ENGINE COOLANT LEVEL LOW WITH NO VISIBLE LOSS OF COOLANT

Range Rover

JLRTB02127NAS5

E363515

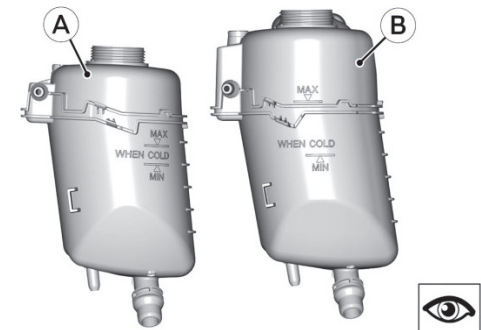
- Inspect the coolant expansion tank.
 - If coolant expansion tank 'B' is installed do not continue with this bulletin. Repair as necessary with reference to TOPIx.
 - If coolant expansion tank 'A' is installed continue to the next step.
- Inspect the coolant level in the coolant expansion tank. If the coolant is at the maximum level in the coolant expansion tank and the 'Coolant Level Low' message is displayed on the instrument panel cluster do not continue with this bulletin. Repair as necessary with reference to TOPIx.
- Continue with the instructions on the technical bulletin where you may be instructed to install a new fuel supply line and coolant expansion tank.
